# SERVICE BULLETIN #126

04/25/14

## 9661 Spoke Wheel

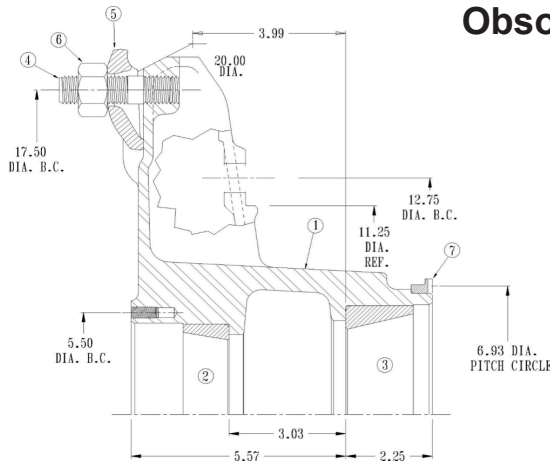
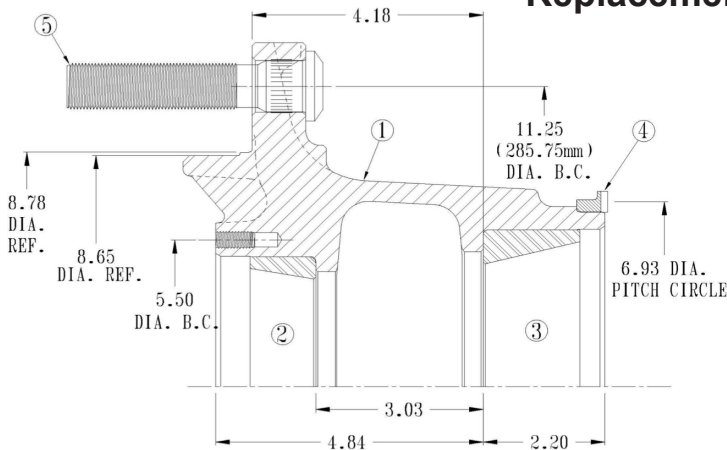
Upon depletion of inventory, the 9661 spoke will become obsolete with no direct replacement. We do however recommend a replacement: the 10-stud 2530 hub. This requires changing brake drums, changing to a disc hub, and changing to disc wheels instead of demountable rims. If you have any questions, please contact the Webb Engineering department via email to [engineering@webbwheel.com](mailto:engineering@webbwheel.com) or call 256-736-6356.
